CRYSTAL RIVER UNIT 3

**SIEMENS TECHNICAL REPORT CT-27438, "MISSILE
PROBABILITY ANALYSIS REPORT PROGRESS ENERGY
CRYSTAL RIVER 3," REVISION 1A (FOR PUBLIC RECORD)**

Missile Probability Analysis Report
Progress Energy
Crystal River 3

Resolution of Comments

FIGURE 10
BB281-18m² DESIGN
COMPARISON OF EXTERNAL MISSILE PROBABILITIES INCLUDING OVERSPEED
WITH NRC LIMIT

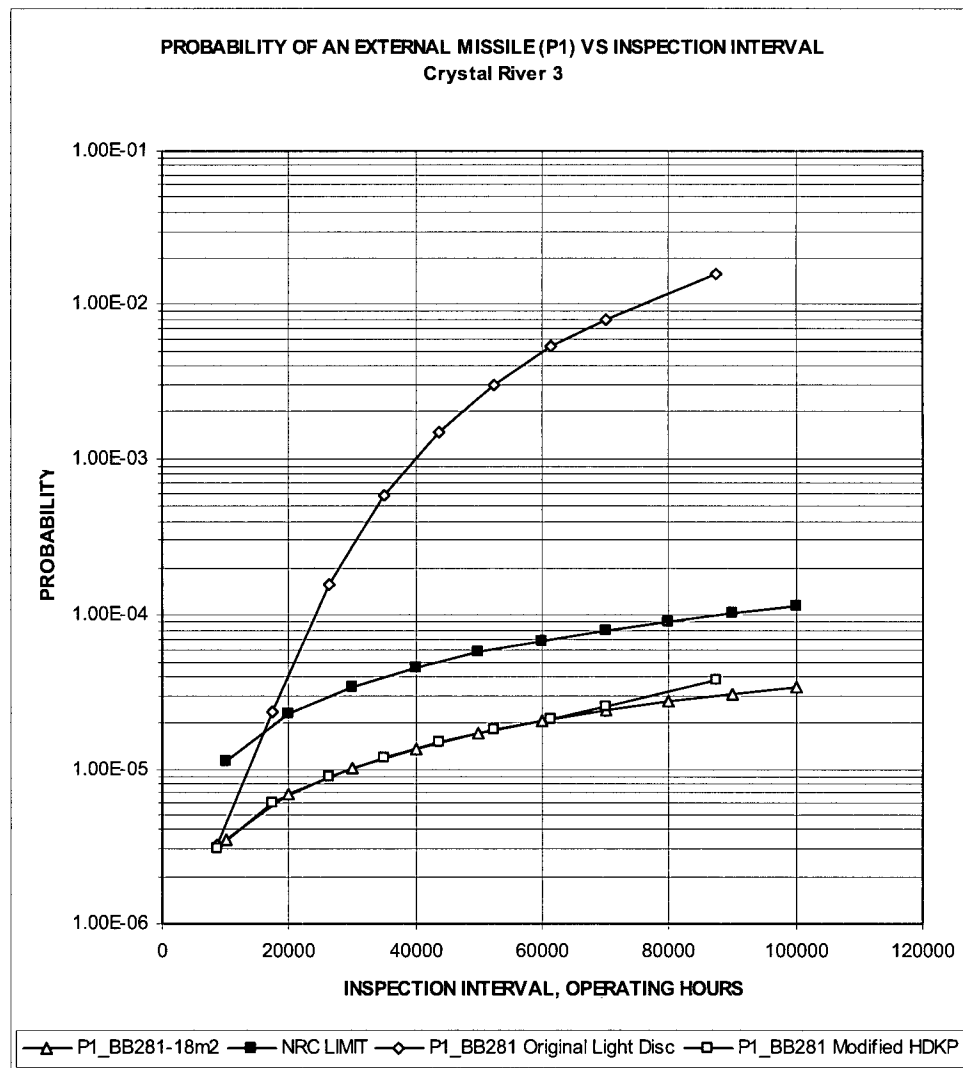
2. Progress Energy Comment: Table 1 indicates action is required when $P1 > 10^{-5}$. Figure 10 indicates $P1$ is $> 10^{-5}$ after 30,000 operating hours and the NRC $P1$ limit curve changes with operating hours. Please explain this and document the $P1$ difference between Table 1 and Figure 10 in the report.

Siemens Response: The probabilities listed in Table 1, which is also found in NUREG 800 as Table 3.5.1.3-1, are in terms of occurrences per year. Figure 10 shows the cumulative probability of occurrence, or the probability of an occurrence per hours of operation. These numbers are not directly comparable.

The "NRC Limit" curve represents a probability of 10^{-5} occurrences/year as it accumulates over the course of 100,000 hours. While the cumulative probability of occurrence exceeds 10^{-5} after 30,000 hours, that is considerably more than one year and thus at no time does the annual probability exceed 10^{-5} occurrences per year.
